Technical Bulletin

Eagle Single Pilot and Copilot Lighting Upgrade

Bell 212

TBN-212-004

Figure 1 – Transistor Bracket Installation

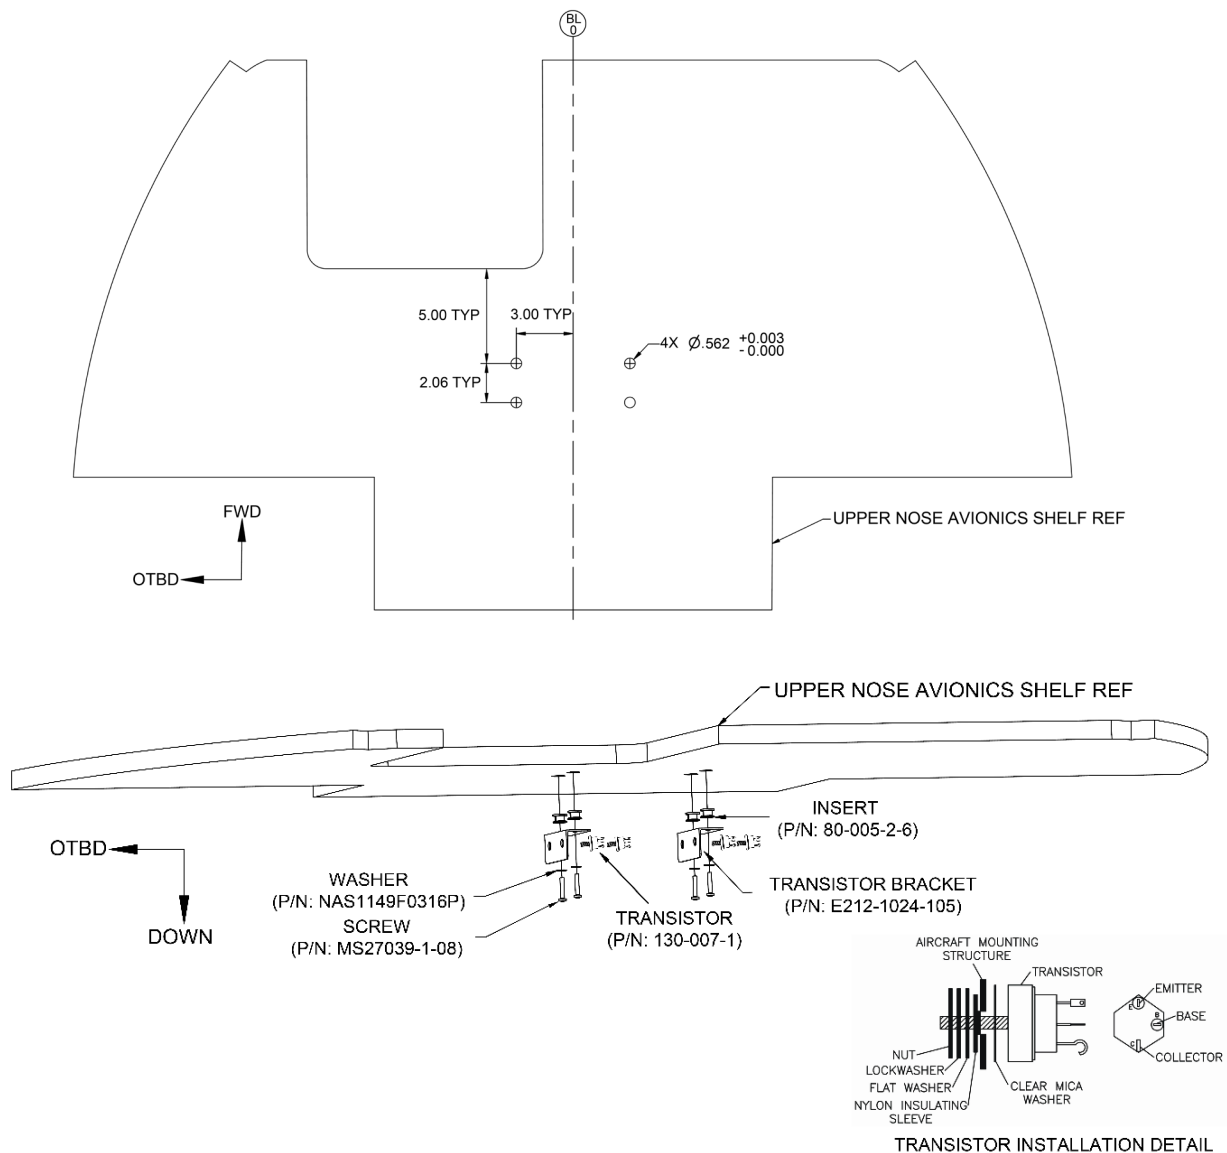
2. Remove the upper nose door to access the Upper Nose Shelf in accordance with Bell Helicopter Maintenance Manual BHT-212-MM.
3. Locate the Upper Shelf and install Inserts and Transistor Brackets in accordance with BHT-ALL-SRM-3-2-12 Application A and Figure 1.

4. Install transistors, Q10, Q11, Q12 and Q13 as shown on Figure 1.
5. On the Overhead Circuit Breaker Panel, locate Rheostat R1 connection 5. Extract and cap and stow wire L49A22-CB.

Figure 2 – Circuit Breaker Installation, Overhead Panel

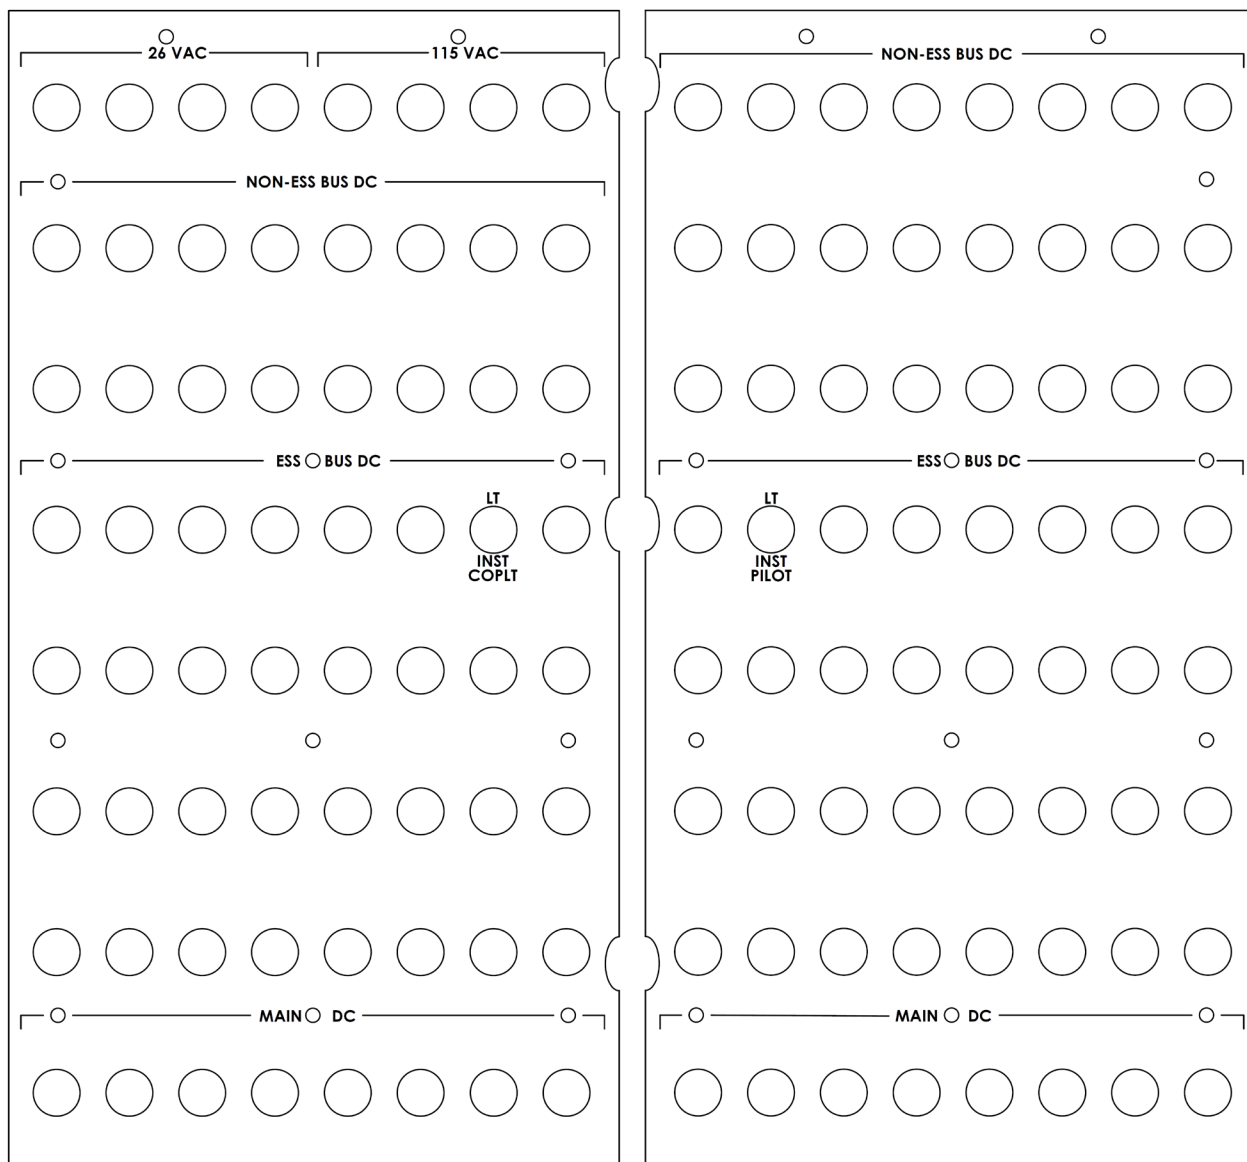
28. On the Overhead Circuit Breaker Panel right hand side, locate and remove LT INST PILOT 3A circuit breaker. Install and terminate wiring to the new 5A circuit breaker as shown on Figure 2 and Figure 3, sheet 1.

29. On the Overhead Circuit Breaker Panel left hand side, locate and remove LT INST COPLT 3A circuit breaker. Install and terminate wiring to the new 5A circuit breaker as shown on Figure 2 and Figure 3, sheet 1.

Figure 3 – TBN-212-004-011 Wiring Diagram

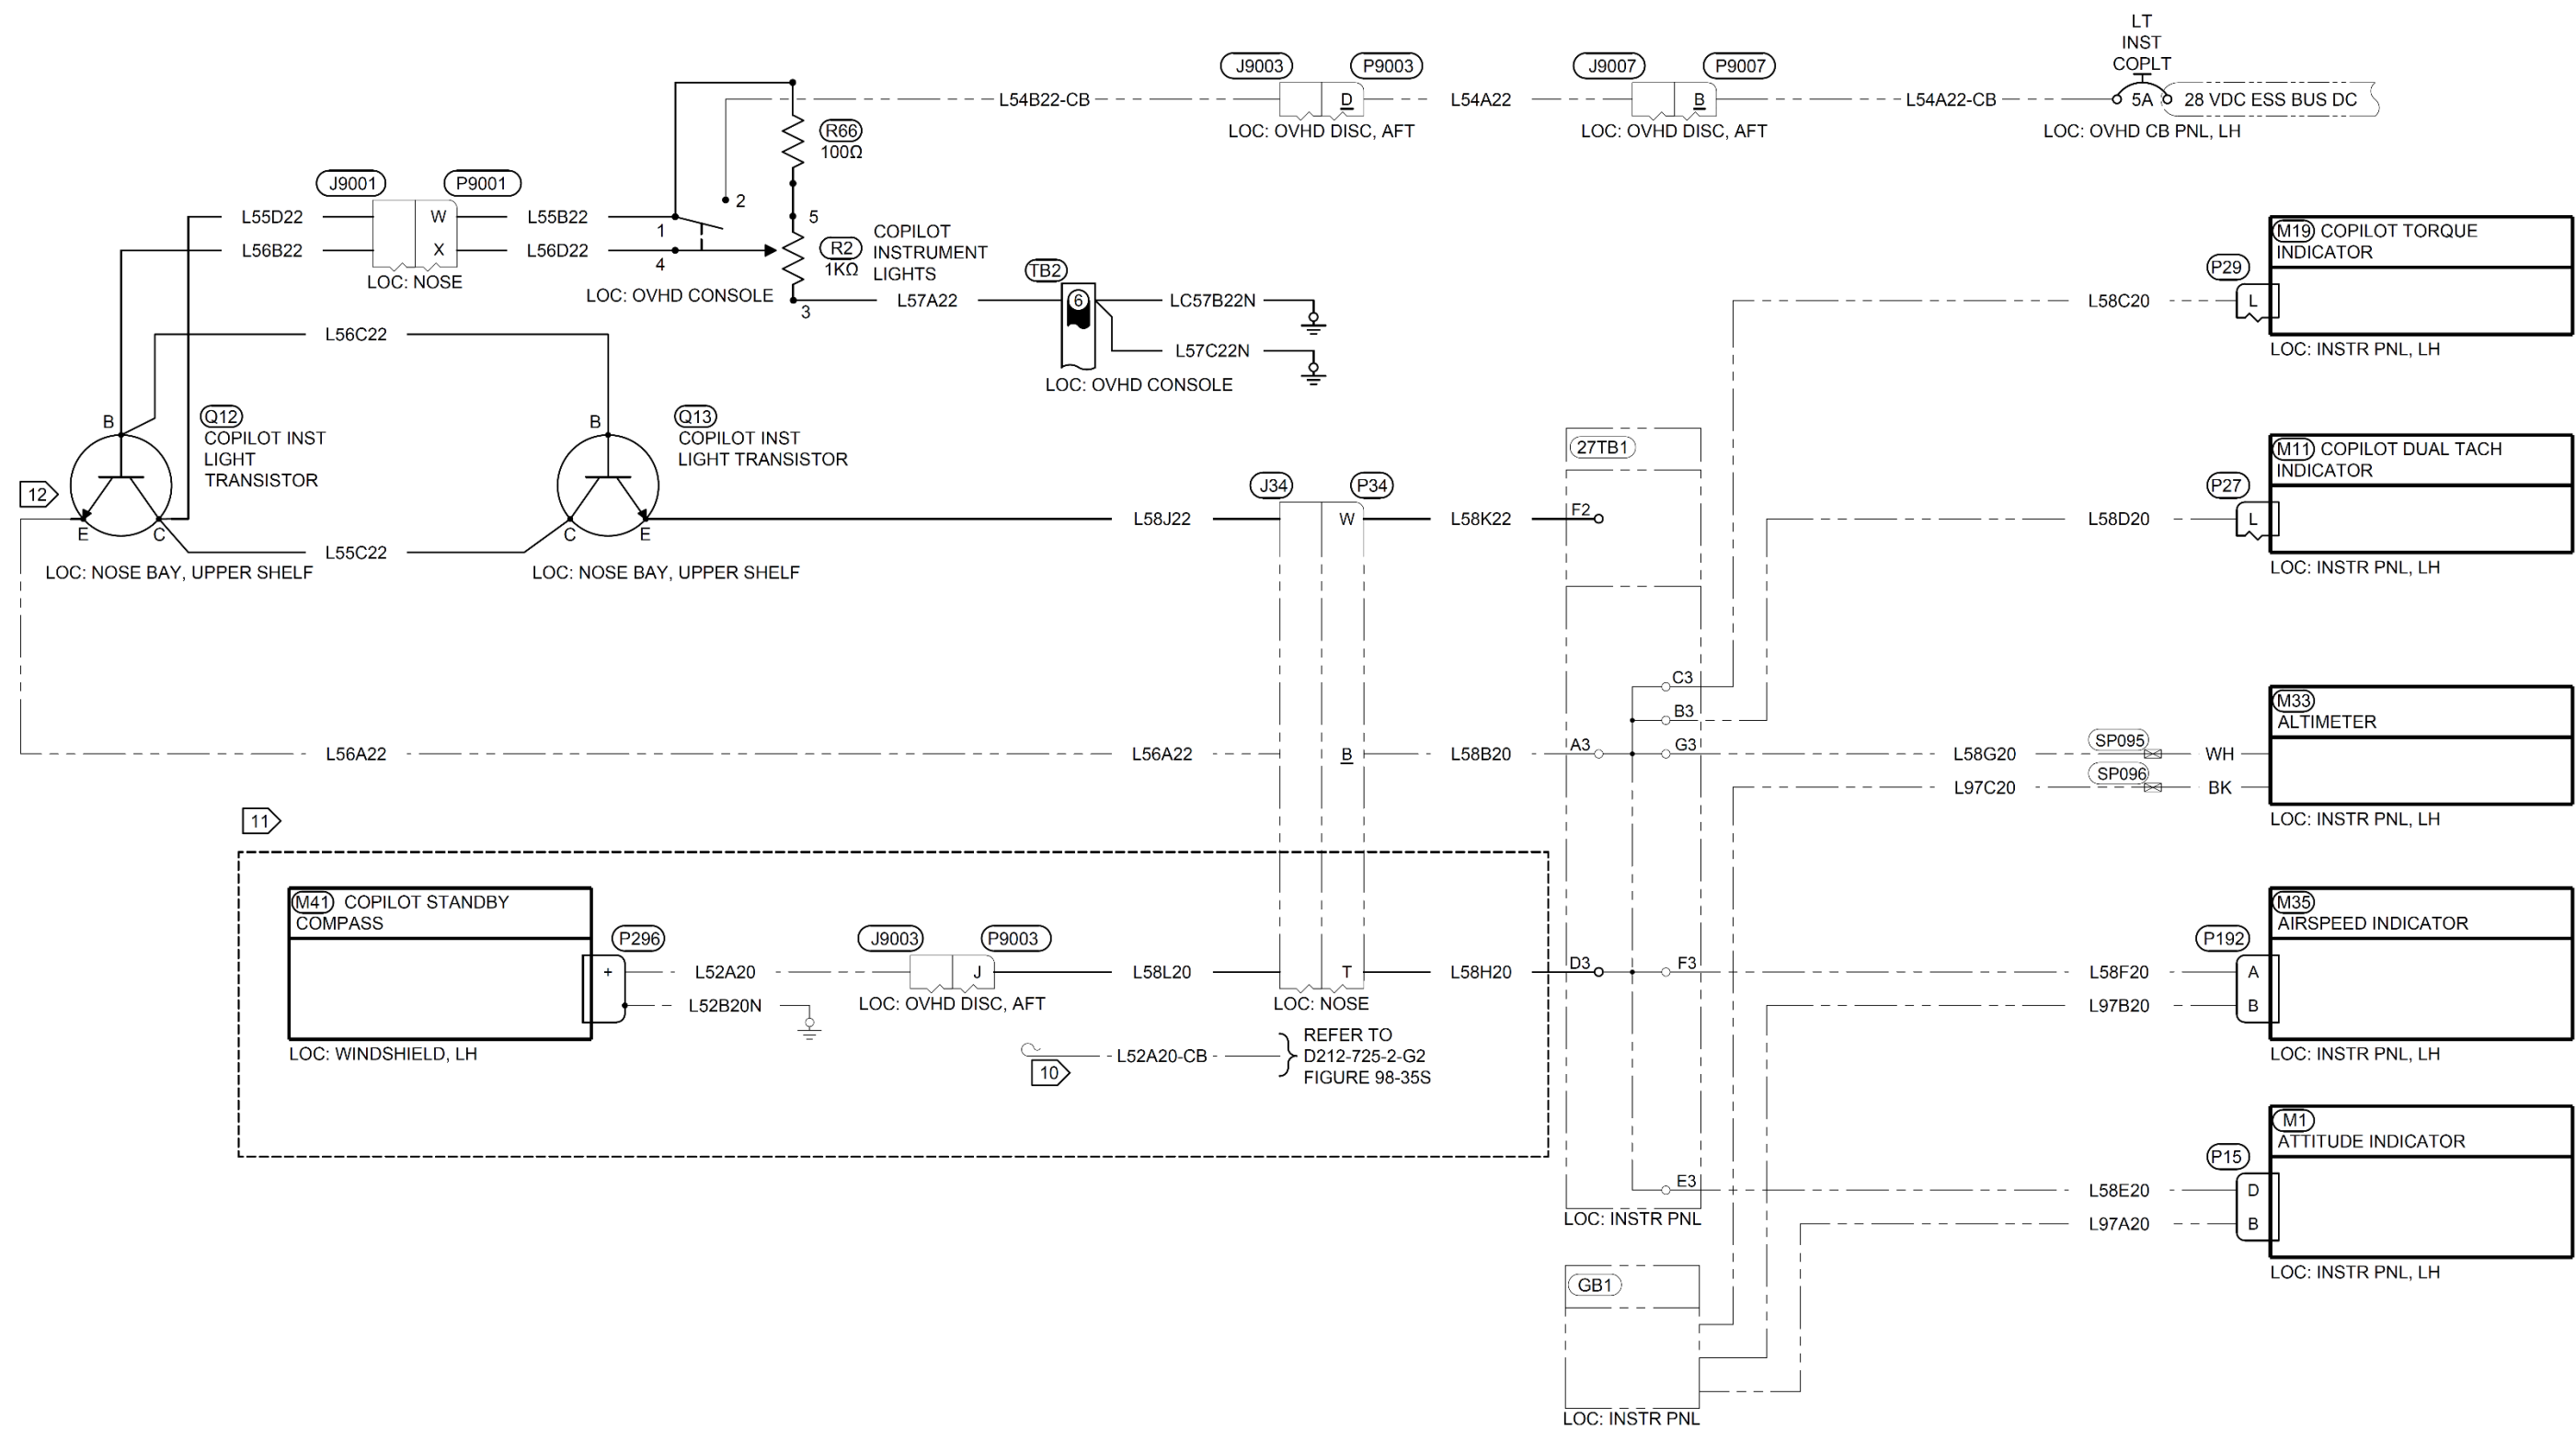
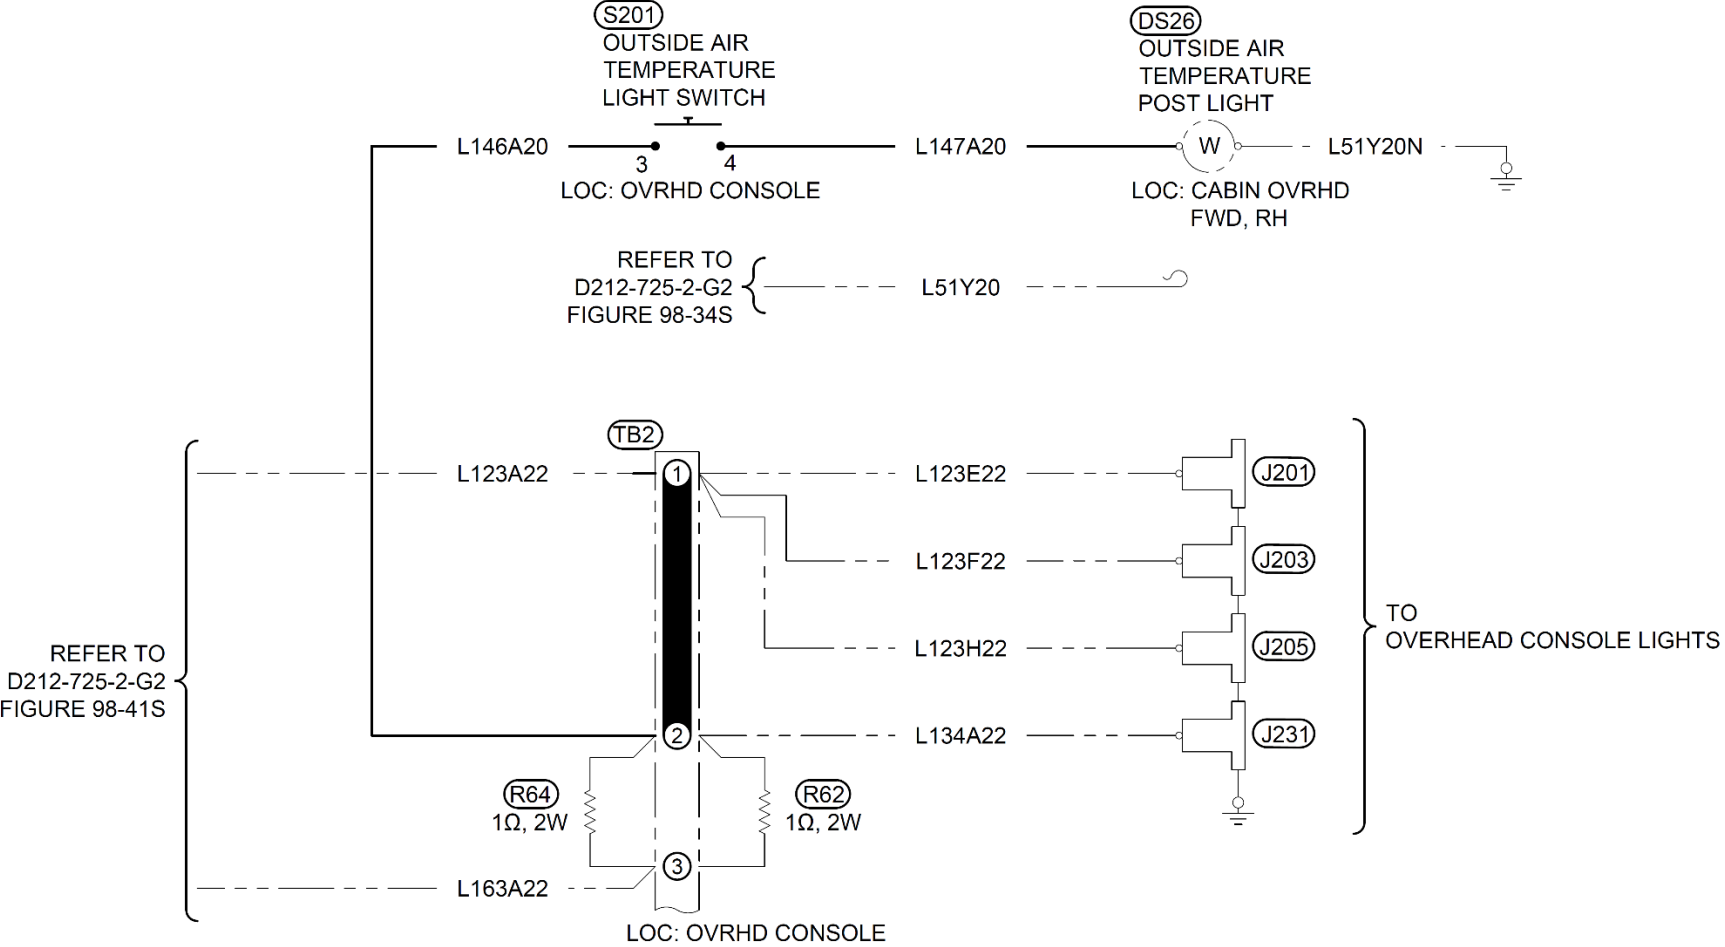
6. From the Overhead Circuit Breaker Panel, Rheostat R1, route and terminate wires to TB3 and P9001 as shown on Figure 3, sheet 1.
7. Install Resistor R65 as shown on Figure 3, sheet 1.

8. From connector J9001, route and terminate wires to the transistor, Q10 as shown on Figure 3, sheet 1.
9. From transistor, Q10, route and terminate wires to the transistor Q11 as shown Figure 3, sheet 1.

10. From transistors, Q10 and Q11, route and terminate wires to the connector, J33 as shown on Figure 3, sheet 1.
11. From connector, P33, route and terminate wire to the terminal module, 27TB1 as shown on Figure 3, sheet 1.

12. From the Overhead Circuit Breaker Panel, Rheostat R2, route and terminate wires to TB2 and P9001 as shown on Figure 3, sheet 2.
13. Install Resistor R66 as shown on Figure 3, sheet 2.

14. From connector P9001, route and terminate wires to the Rheostat R2 as shown on Figure 3, sheet 2.
15. From connector J9001, route and terminate wires to the transistor, Q12 as shown on Figure 3, sheet 2.

16. Extract L56A22 from the connector, J9001 pin N, relocate and terminate L56A22 to the transistor, Q12 as shown on Figure 3, sheet 2.
17. From transistor, Q12, route and terminate wires to the transistor, Q13 as shown Figure 3, sheet 2.

18. From transistors and Q13, route and terminate wire to the connector, J34 as shown on Figure 3, sheet 2.
19. From connector, P34, route and terminate wires to the terminal module, 27TB1 as shown on Figure 3, sheet 2.

20. If required, extract and cap and stow L52A20-CB from connector P9003 pin J as shown on Figure 3, sheet 2.
21. If required, route and terminate wire L58L20 from connector P9003 to, J34 as shown on Figure 3, sheet 2.

22. If required, route and terminate wire L58H20 from connector, P34 to terminal module 27TB1 as shown on Figure 3, sheet 2.
23. Install S201 Outside Air Temperature Light Switch on the Overhead Console as shown on Figure 5.

24. From the Outside Air Temperature Post Light, DS26, extract and cap and stow wire L51Y20.
25. From the Outside Air Temperature Post Light, DS26, route and terminate wire L147A20 to the Outside Air Temperature Light Switch, S201 as shown on Figure 3, sheet 3.

26. From the Outside Air Temperature Light Switch, S201, route and terminate wire L146A20 to the Terminal Board, TB2 as shown on Figure 3, sheet 3.
27. Access Overhead Circuit Breaker Panel left and right hand side in accordance with Bell Maintenance Manual BHT-212-MM.
